## **Encroachment Appeal - 100 Maclean Avenue**

**Date:** May 30, 2019  
**To:** Toronto East York Community Council  
**From:** Manager, Permits and Enforcement, Transportation Services  
**Wards:** Ward 19  
**Ref. #:** P:\2019\Cluster B\TRA\Toronto and East York\Te2019016.te.row.docx

**100 MACLEAN AVE - WALL CROSS SECTION DRAWINGS**

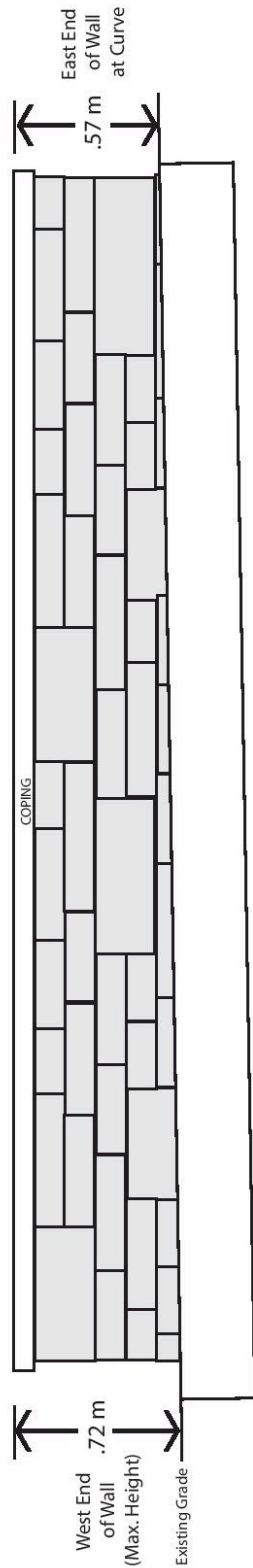
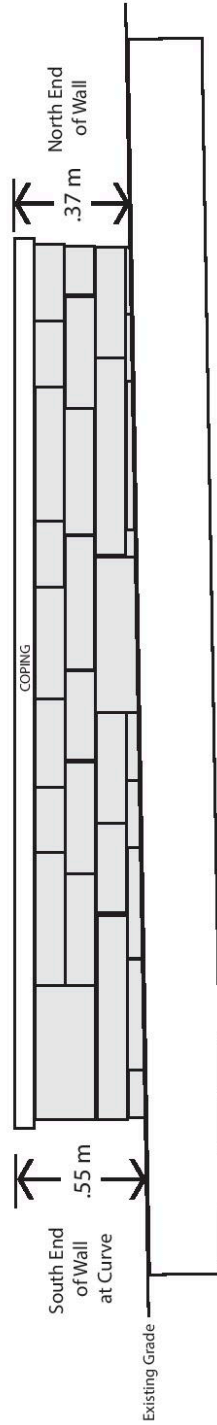
Comments: (The revised retaining wall has 600mm horizontal clearance away from existing hydro pole #8)
